SERVICE BULLETIN

APPLICABILITY: 2014-19 Legacy & Outback

NUMBER: 07-223-23R

SUBJECT: New Genuine Subaru Replacement Battery (SOA821B950)

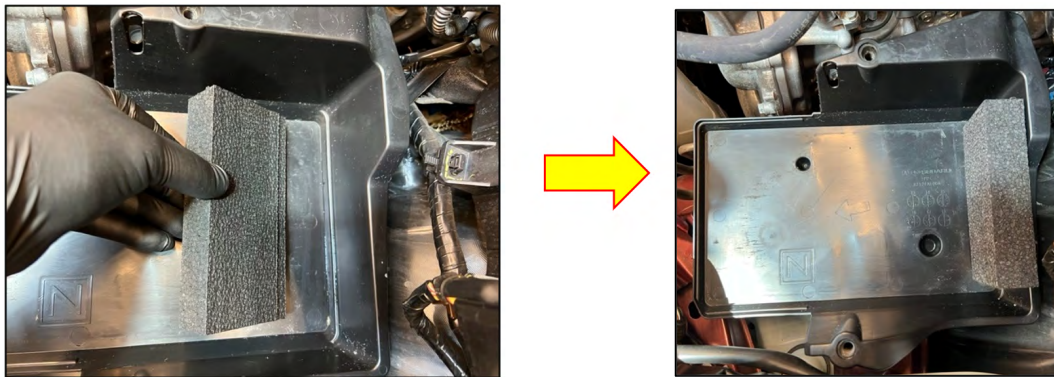
STEP 2: Install the NEW battery cover (82423AN000) to the replacement battery. Confirm the bottom of the cover is aligned flush with the bottom of the battery.

- A. **2.5L Equipped Models ONLY:** Install the battery as per the applicable Service Manual: Engine > STARTING/CHARGING SYSTEMS > Battery > Installation. Proceed to Step 6.
- B. **3.6L Equipped Models ONLY:** Install the battery with spacer (82190AL000) to the rear side of the battery tray. The spacer must be installed with the flat side against the battery and the notched portion facing the bottom of the battery tray. See the images below.

IMPORTANT NOTE: ALWAYS confirm the spacer fitment is flush when securing the battery with the hold down and hold down rods.
